**ADDENDUM # 1**

<b>Project</b>	TA Blakelock High School Renovations	<b>Project No.</b>	2215-C
<b>Location</b>	1160 Rebecca Street, Oakville, ON	<b>Date of Issue</b>	2025 04 24
<b>Owner</b>	Halton District School Board	<b>File</b>	2215/7.1.3

This Addendum forms part of the Contract Documents and amends the original Drawings and Specifications, dated 2025 04 17, and all preceding Addenda, as noted below.

4 PARTIAL FLOOR PLAN - LEVEL 1 & 1A  
A100 1:50

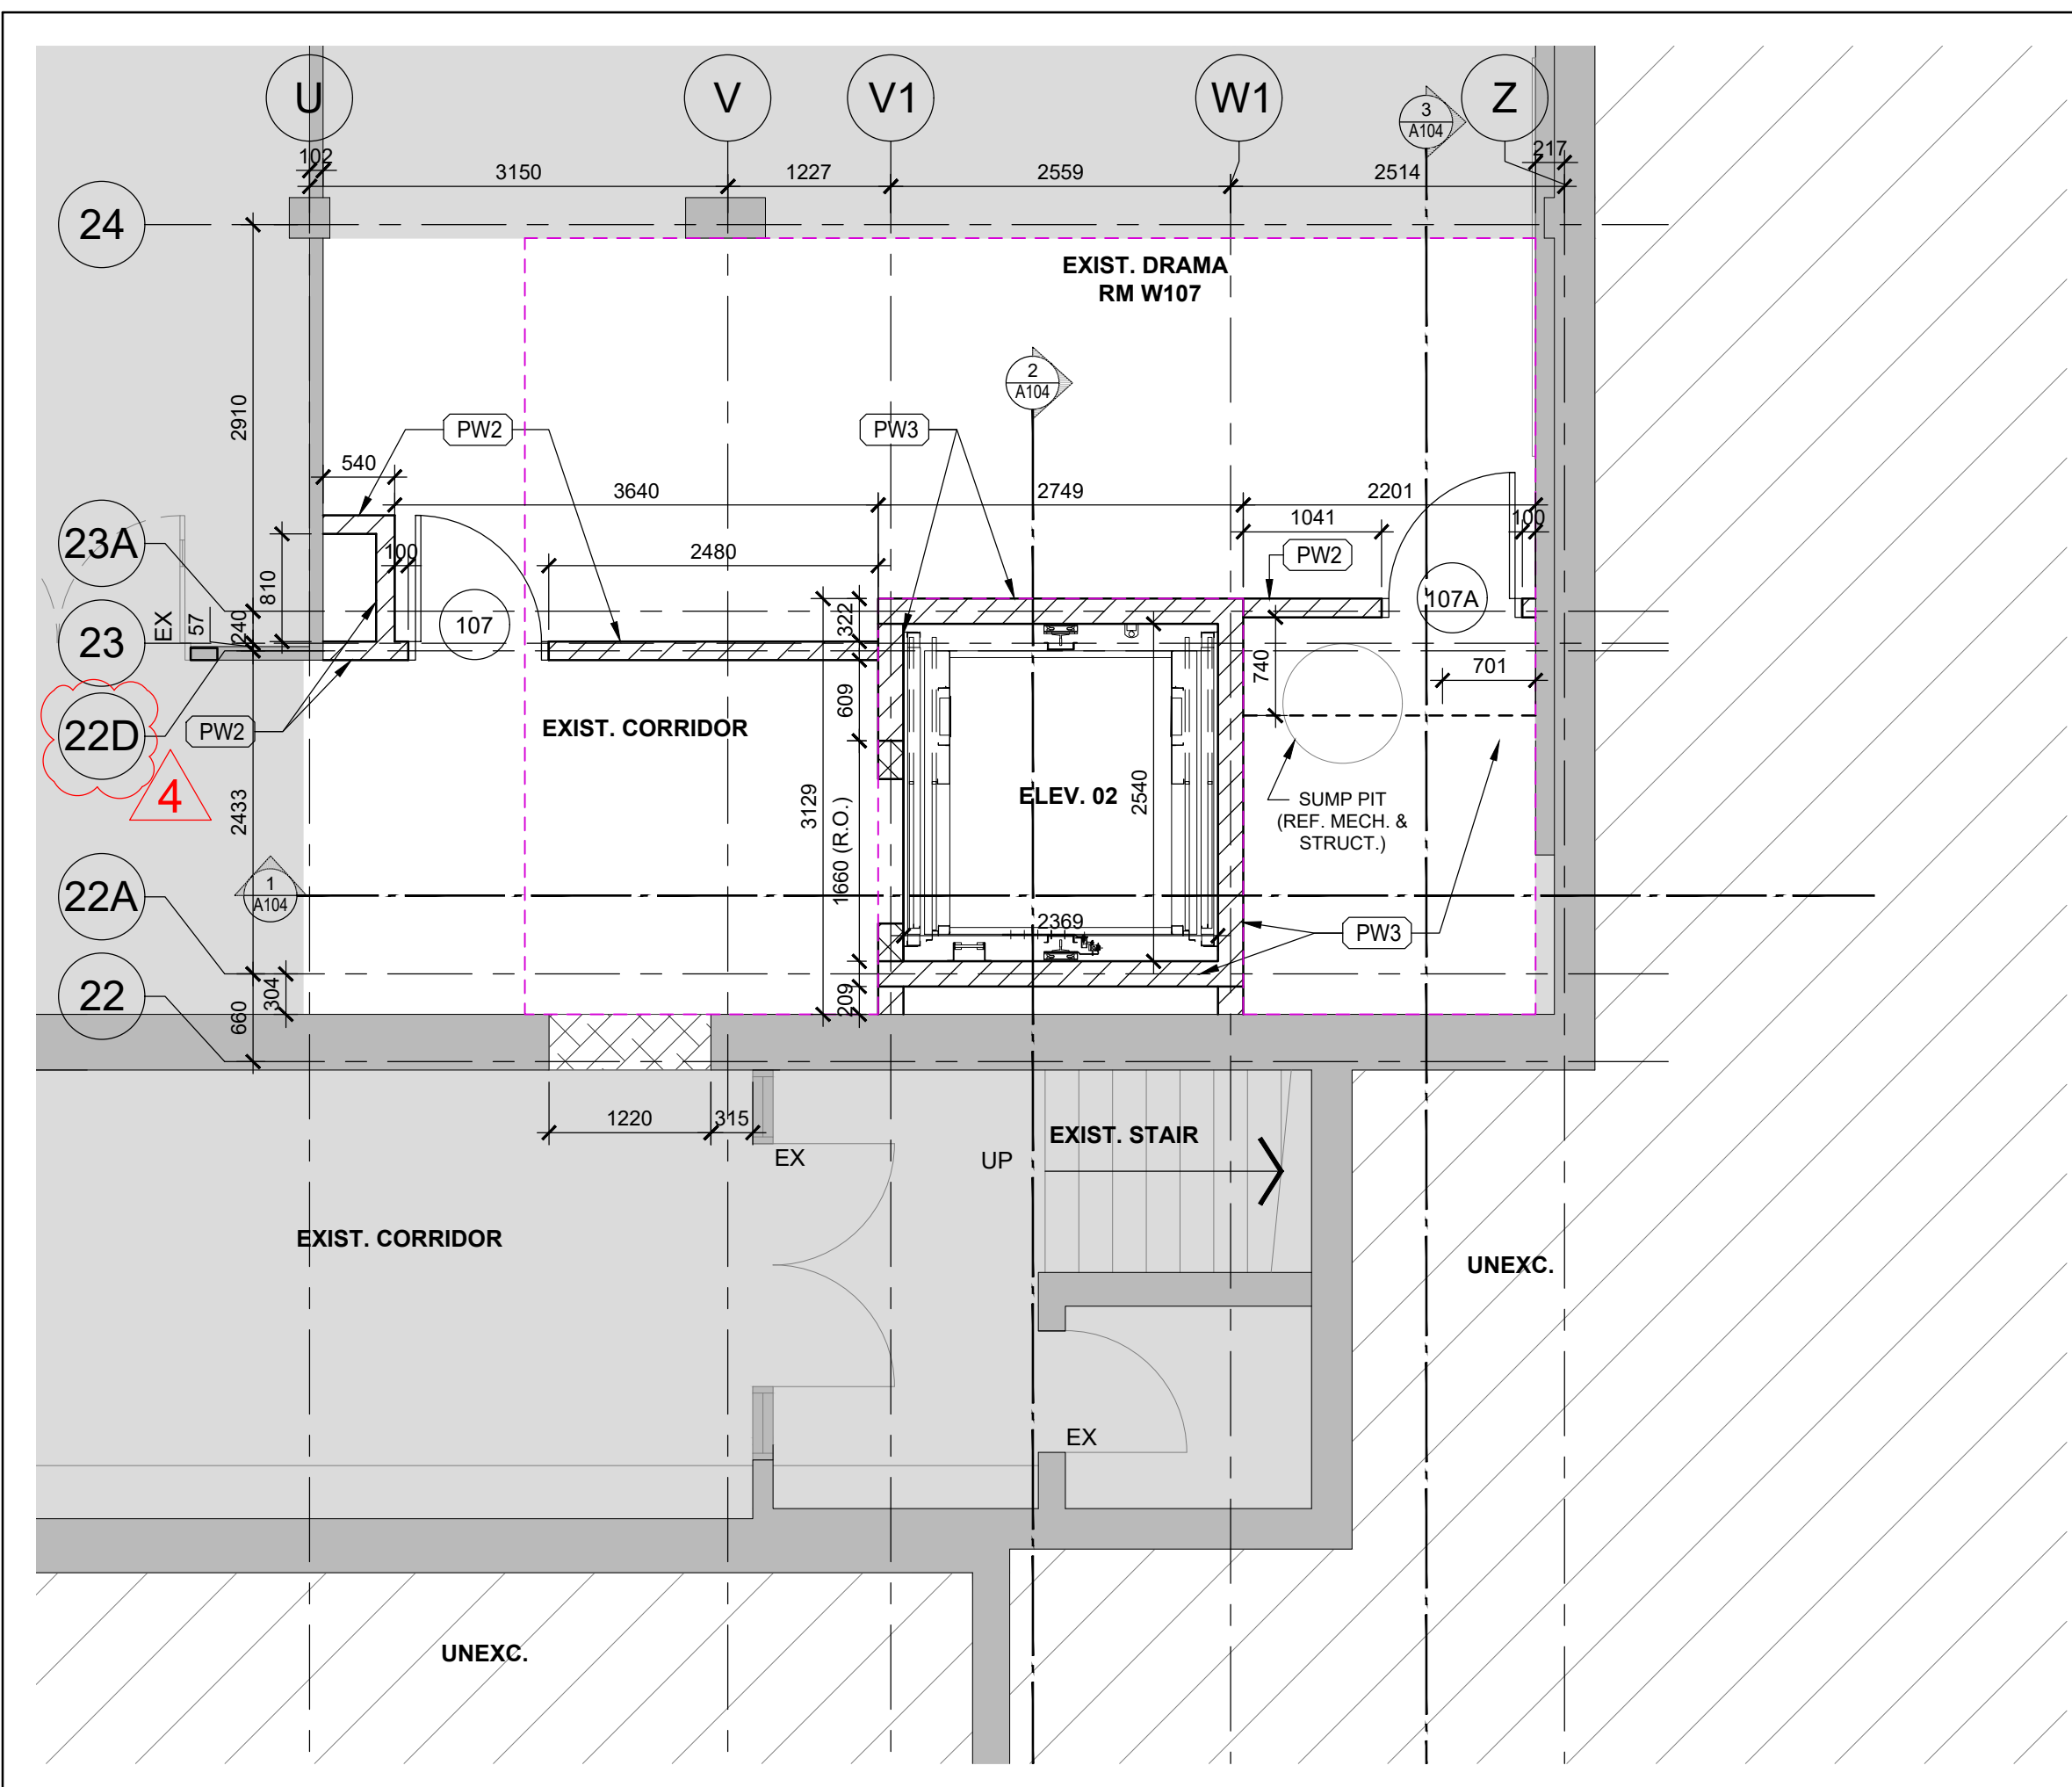
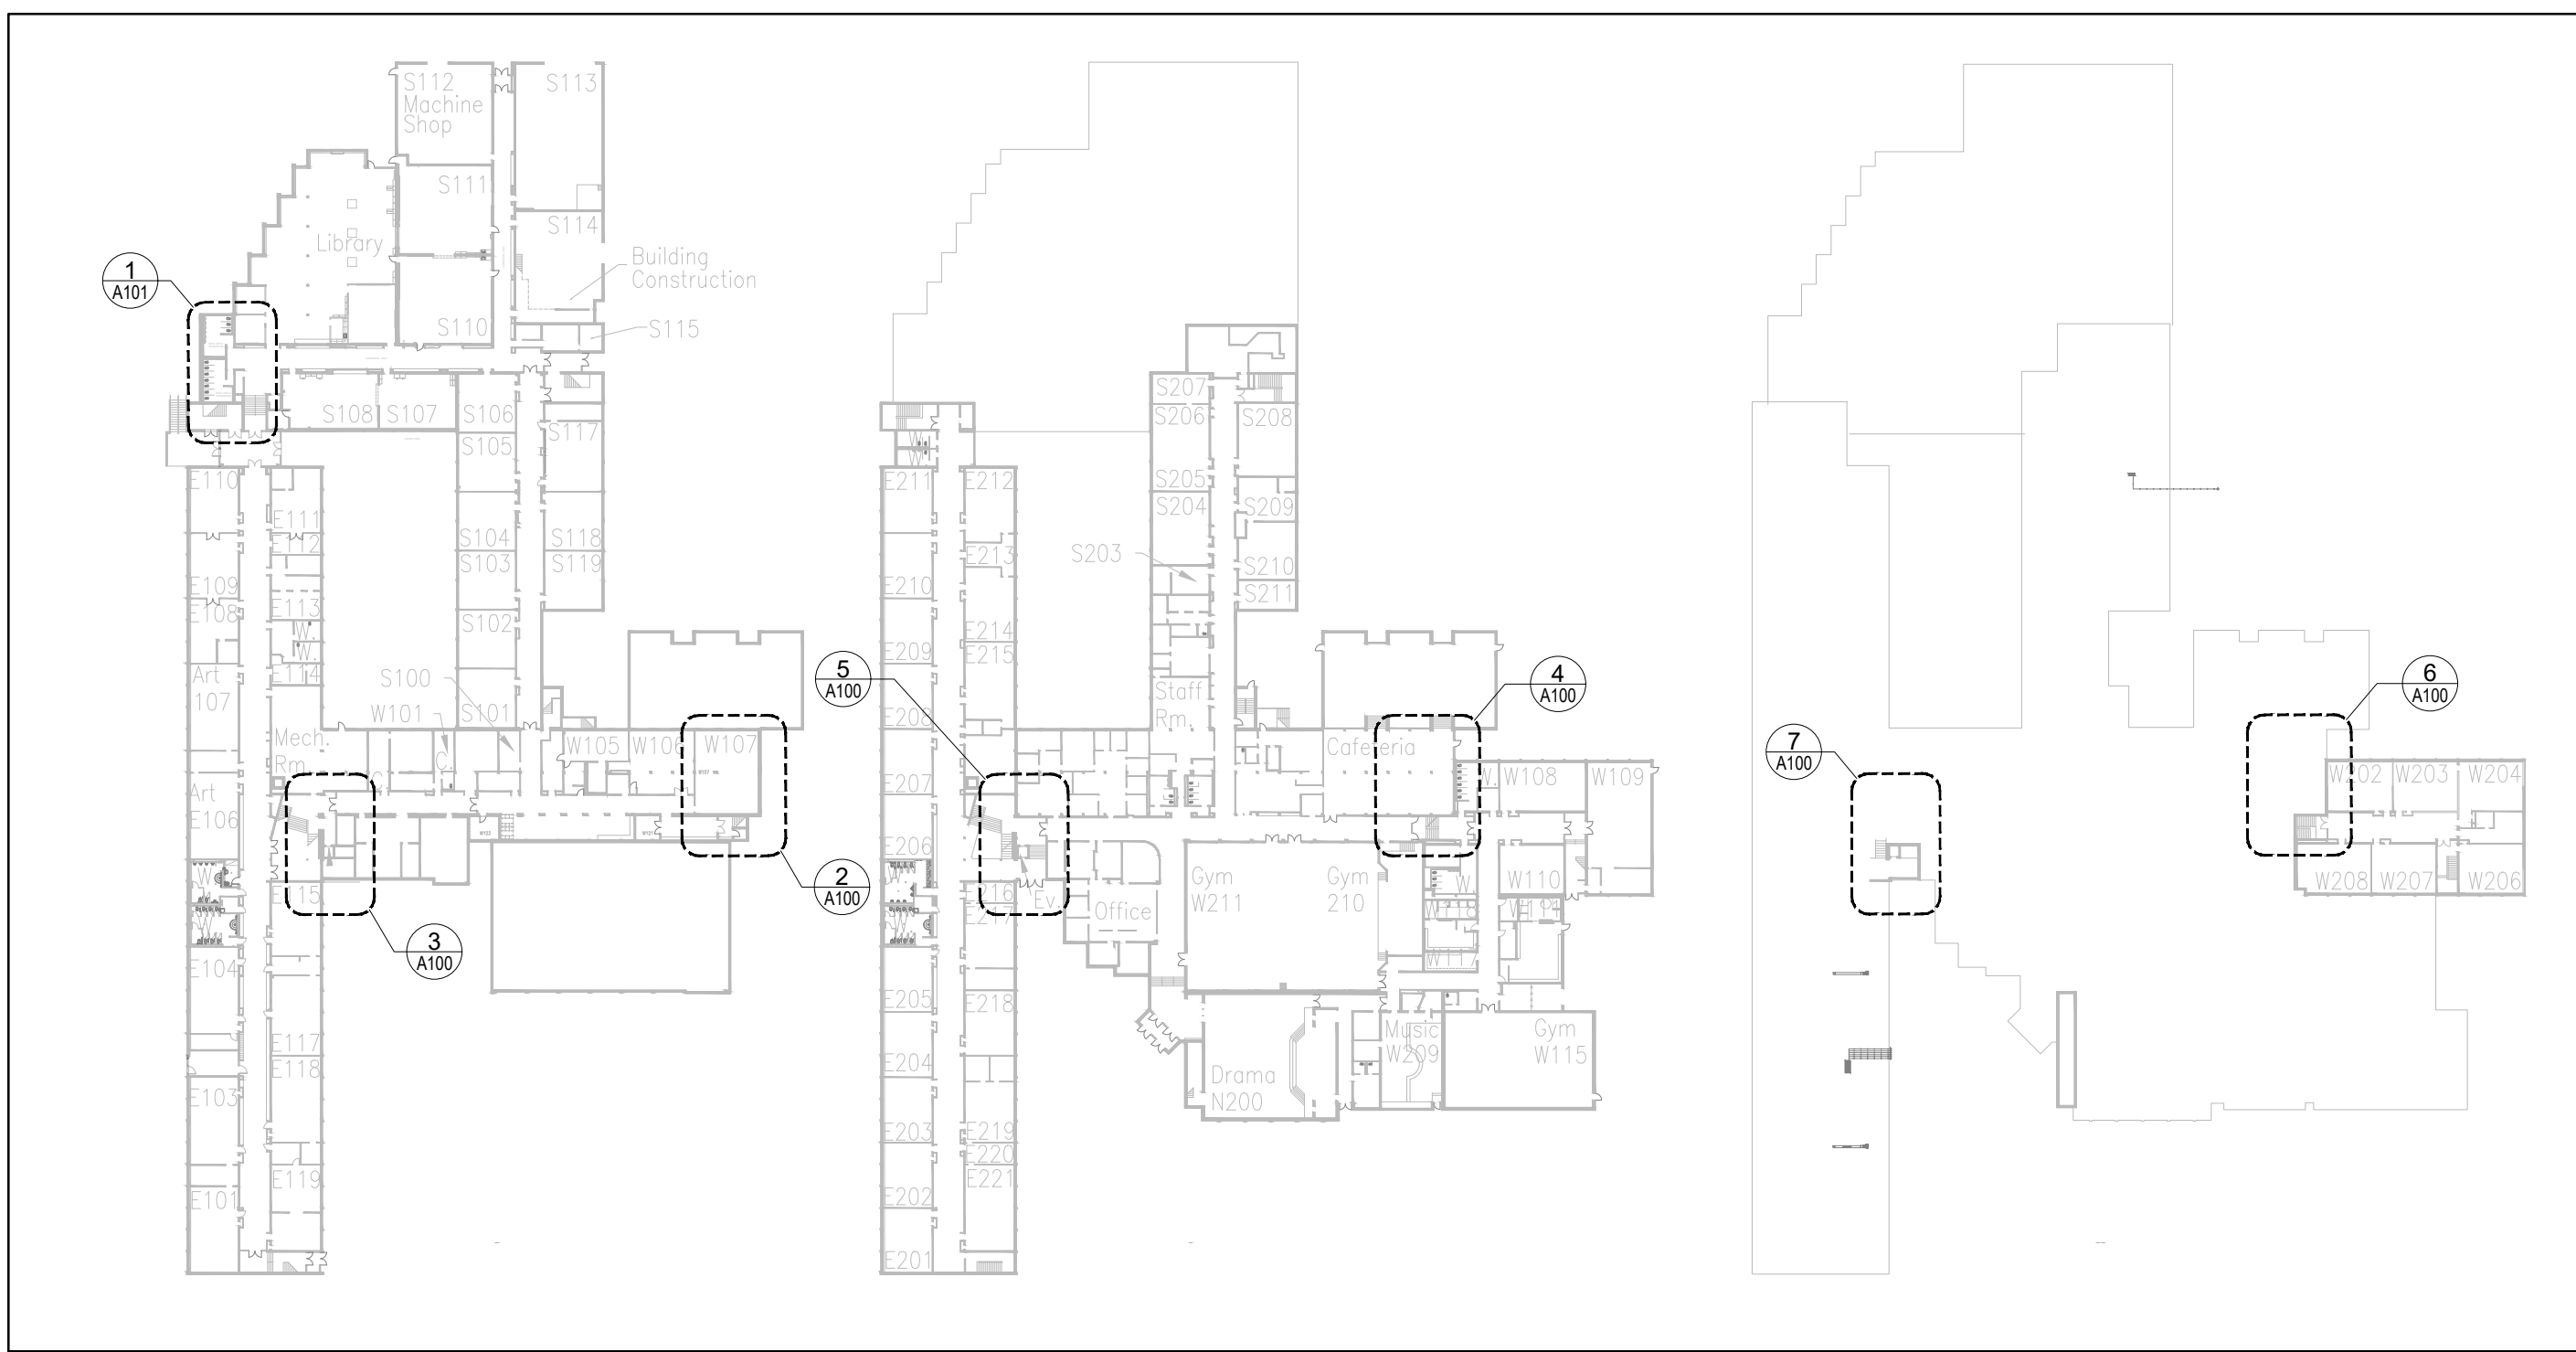
- .1 Replace drawing with the attached Revision No. 4.
- .2 Drawing reissued to clarify scope and include new walls/chase based on coordination with Mechanical and Electrical drawings.
